LINCOLN CITY/LANCASTER COUNTY PLANNING STAFF REPORT

P.A.S.: Change of Zone #3332 and Preliminary Plat # 01011
Rolling Meadows 1st Addition

PROPOSAL: A request for a change of zone from AG Agriculture to AGR Agriculture Residential and a Preliminary Plat for 23 lots.

Preliminary Plat #01011
Change of Zone #3332
SW 33rd & W Denton Rd.

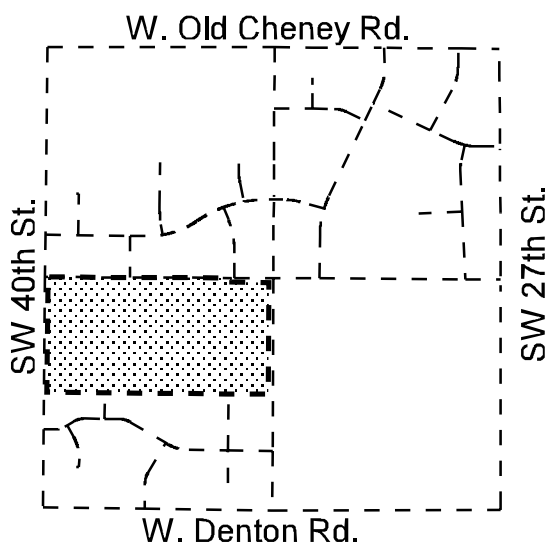
4. The applicant is requesting waivers of the 1320' block length requirement for Block 1 and Block 2. The waiver for Block 2 as this reflects the abutting plating and topography. An access road should be provided to SW 40th Street, as required by the subdivision ordinance and as provided by the subdivisions to the north and south of this plat. There is no engineering or physical reason to justify the waiver of block length on Block 1.

6. The County Engineer's letter of September 20, 2001 requests the following:
 - 1) The typical cross-section for the paving of SW 33rd Street should show 7" asphalt type SP-2, and the shoulder width should be 6 feet.
 - 2) All interior intersections shall have a minimum of 30 feet radius returns. Intersections along SW 33rd Street shall have a minimum of 50 feet radius.
 - 3) The culvert calculations table details do not match the information on the plan view with respect to culvert size, length and station.
 - 4) The culvert at Sta. 9+27 on SW 38th Street will require a permanent easement on the outlet.
 - 5) The vertical curves at Sta 0+30 on SW 34th Court and at Sta. 31+83.65 on West Burgess Lane are too short. The minimum K for a 25 mph sag curve is 30.
 - 6) Developer shall enter into a pavement maintenance agreement with Lancaster County prior to final plat approval.

1. After the subdivider completes the following instructions and submits the documents and plans to the Planning Department office, the preliminary plat will be scheduled on the City Council's agenda: (NOTE: These documents and plans are required by ordinance or design standards.)
 - 1.1 Revise the preliminary plat to show a street connection from SW 40th Street to SW 38th St.
 - 1.2 Revise the preliminary plat to show the changes requested by the County Engineer.
2. The City Council approves associated request:
 - 2.1 Change of Zone # 3323, AG to AGR

- 2.2 An exception to the design standards to permit block length in excess of 1320 for Block 2
- 2.3 A waiver to the sidewalk, street lighting, landscape screen, and street tree requirements since the area of each lot exceeds 1 acre and the subdivision will not be annexed.
- 2.4 A modification to the requirements of the land subdivision ordinance to permit double frontage lots along the county roads.
